Piper Aircraft Corporation

SUBJECT: Inspection of Circuit Protector Wiring

MODELS AFFECTED: PA-24 and PA-24 "250" Comanches Serials 24-2512 to 24-2600 inclusive

SERVICE BULLETIN 205

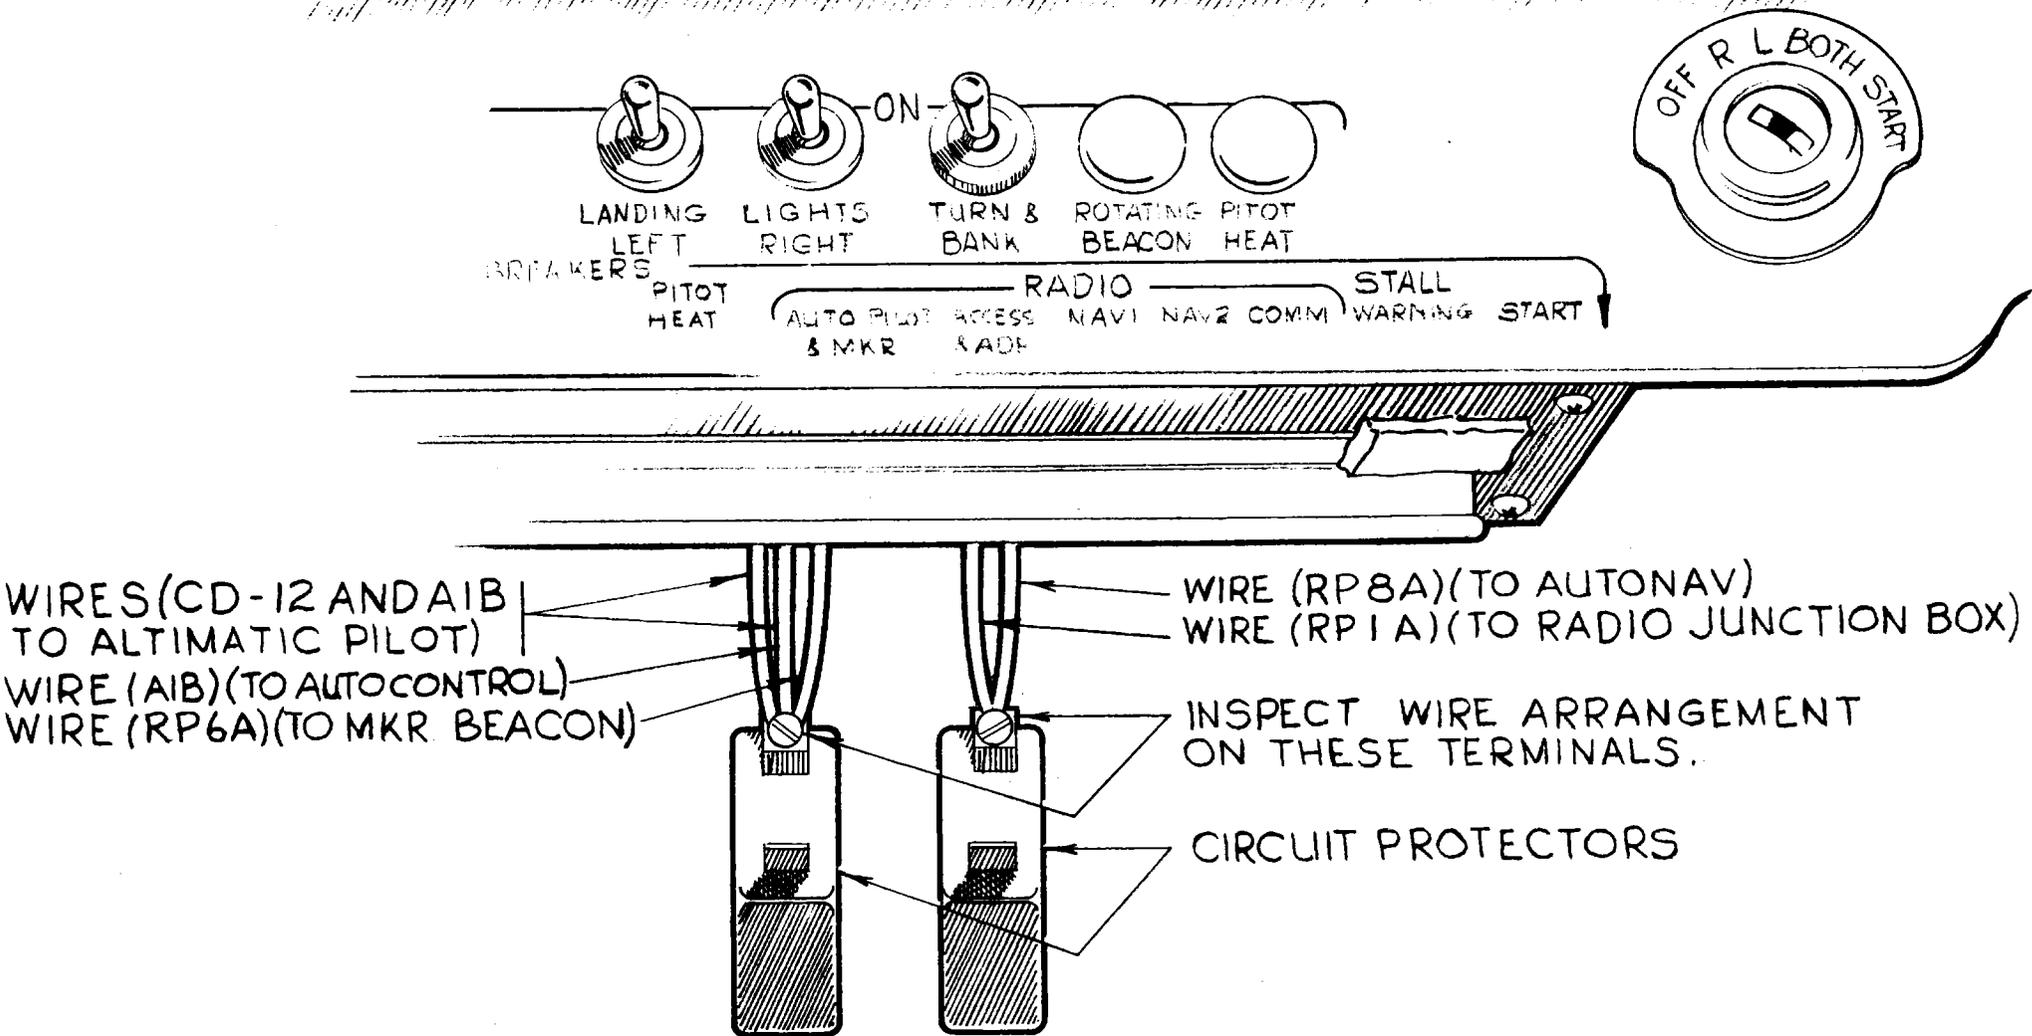
The two circuit protectors - (1) the Accessory and ADF circuit protector and (2) the AutoPilot and Marker Beacon circuit protector (to which the Piper Altimatic, Piper AutoControl or Narco Radio installation packages Numbers 1, 2 or 3 are installed) - may be wired in reverse.

It is requested that the wiring to these two circuit protectors be inspected, referring to the drawing on the reverse side of this Bulletin for the correct wiring.

If the inspection of the wiring and the test as outlined above are satisfactory, no further action will be required. However, if the circuits are wired in reverse, then they must be rewired as indicated by the referenced sketch.

Upon completion of the above inspection, the following test is to be made to assure that the circuit protectors are wired correctly.

1. Open only the Accessory and ADF circuit protector. Be sure only the Accessory and ADF are inoperative. The Accessory may be checked by keying the hand microphone and noting whether or not there is a click in the speaker. There should be no clicking with the Accessory and ADF circuit protector opened. Reset the circuit protector.
2. Open only the AutoPilot and Marker Beacon circuit protector. Be certain only the AutoPilot and Marker Beacon are inoperative. The Accessory and ADF should be operative.
